August 22, 2014  
GO2-14-126

Subject: **COLUMBIA GENERATING STATION, DOCKET NO. 50-397  
LICENSE AMENDMENT REQUEST TO REVISE TECHNICAL  
SPECIFICATION SURVEILLANCE REQUIREMENT FOR THE ULTIMATE  
HEAT SINK**

## **Evaluation of Proposed Change**

Figure 1 – Simplified Diagram

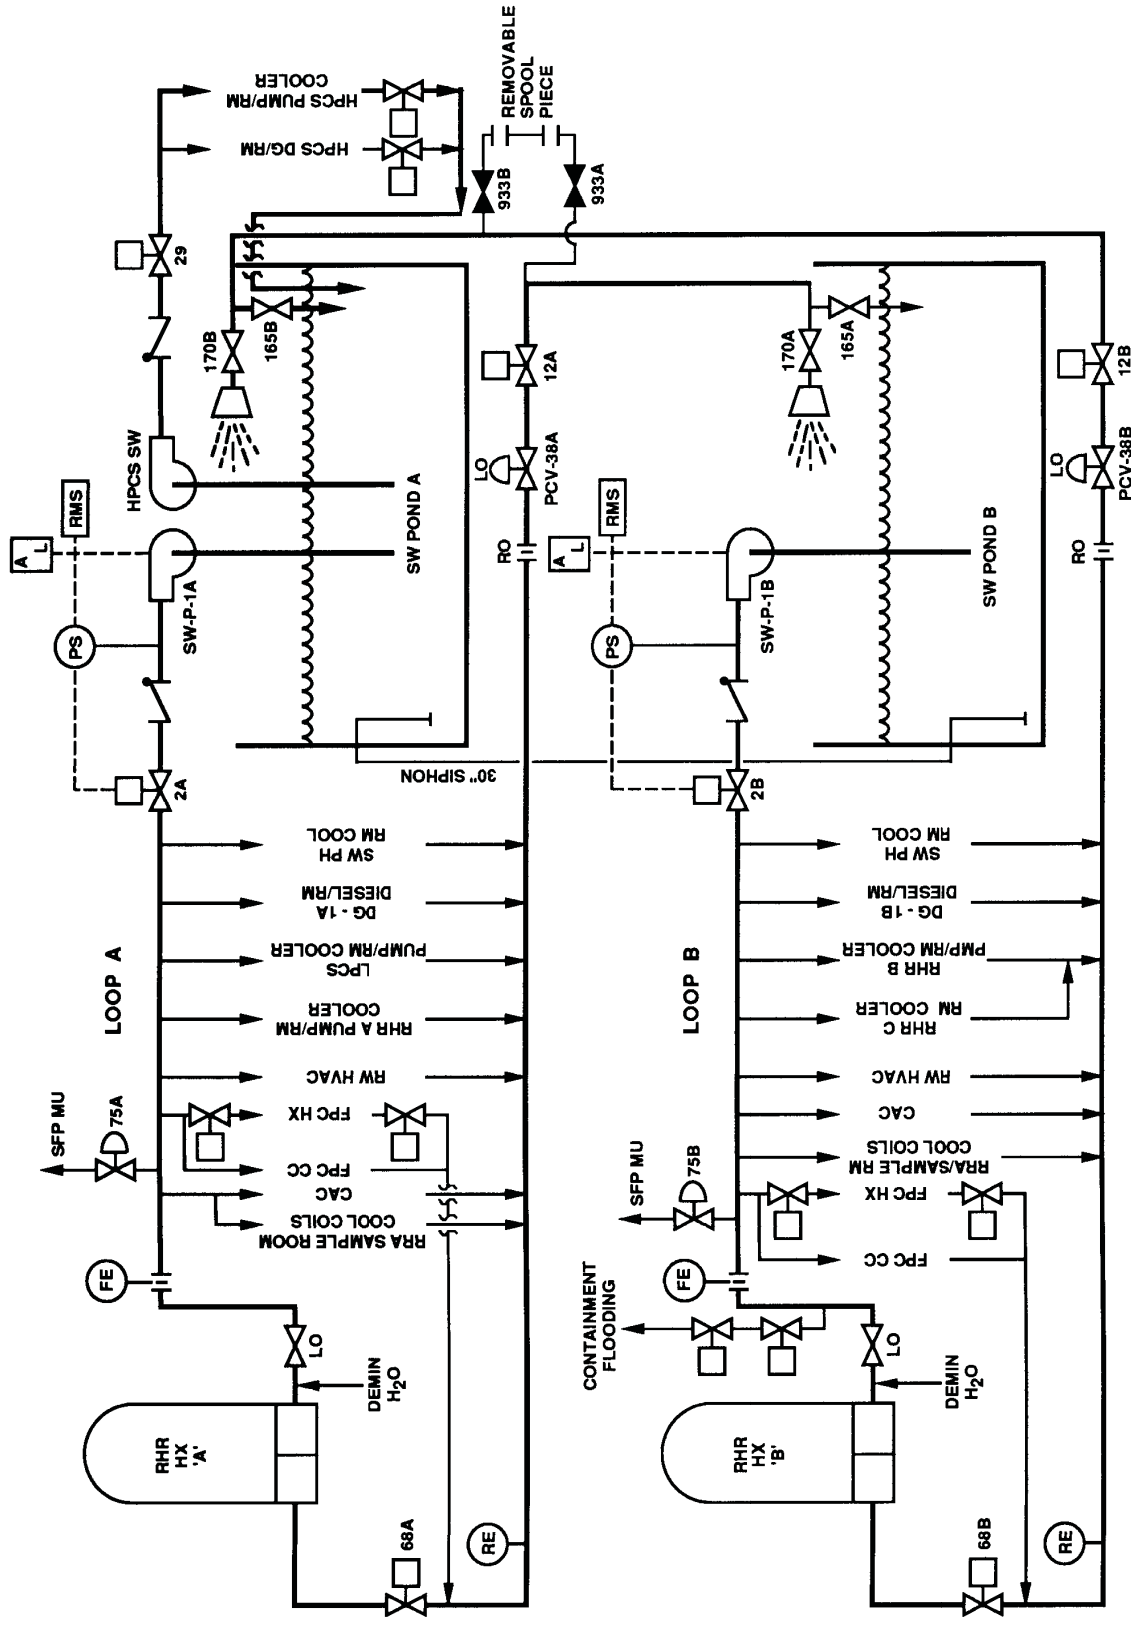
the Division 1 equipment, and discharges through a spray ring into pond B for heat dissipation. Similarly, SW loop B draws water from pond B, cools Division 2 equipment, and discharges through a spray ring into pond A. The water then returns to the initial pond through a 30 inch diameter siphon line. Figure 1 contains a simplified sketch of the UHS and SW system.

Figure 2 – Spray Pond Levels

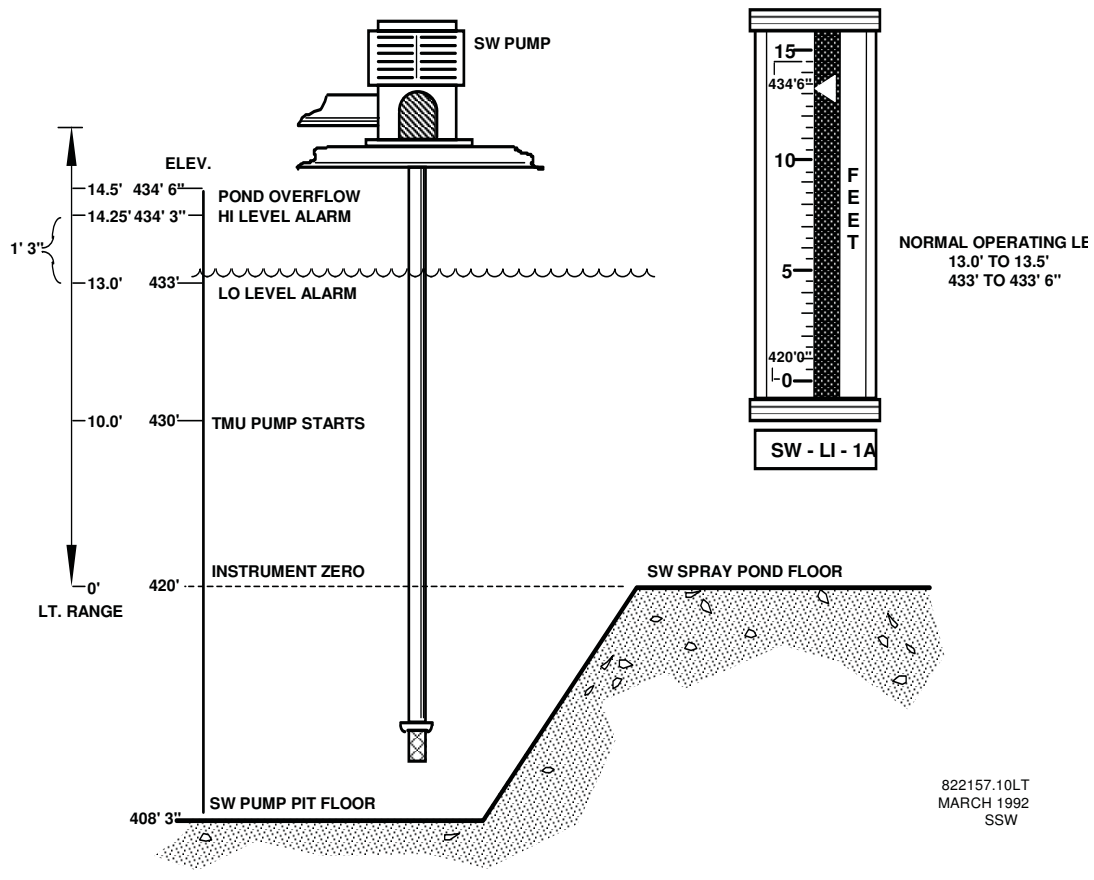
Normal level in the spray ponds is maintained less than 433.5 feet. The high level alarm is at 434.25 feet. The pond overflow is at 434.5 feet. Figure 2 contains a depiction of the spray pond levels.

With one SW pump in operation, the level in the associated pond drops approximately 9-11 inches (0.75-0.92 feet) while the level in the other pond rises by an equivalent amount for a total differential level of 18-22 inches (1.50-1.83 feet). In order to meet the minimum level of 432.75 feet when one SW pump is in operation, the normal level in the ponds would need to be maintained slightly above 433.5 feet. Once the SW pump starts, the level in the pond providing the pump suction will drop to approximately

For instance, with the level in the spray ponds maintained at or slightly below 433.25 feet, the level change due to a single SW pump start is acceptable. That is, the level in the pond with the operating pump will drop to approximately 432.25 feet while the level in the other pond will rise to approximately 434.25 feet. There is a net conservation of water inventory between the two ponds.

Specifically, SR 3.7.1.1 will be revised from "Verify the water level of each UHS spray pond is  $\geq$  432 ft 9 inches mean sea level" to "Verify the average water level in the UHS spray ponds is  $\geq$  432 feet 9 inches mean sea level."
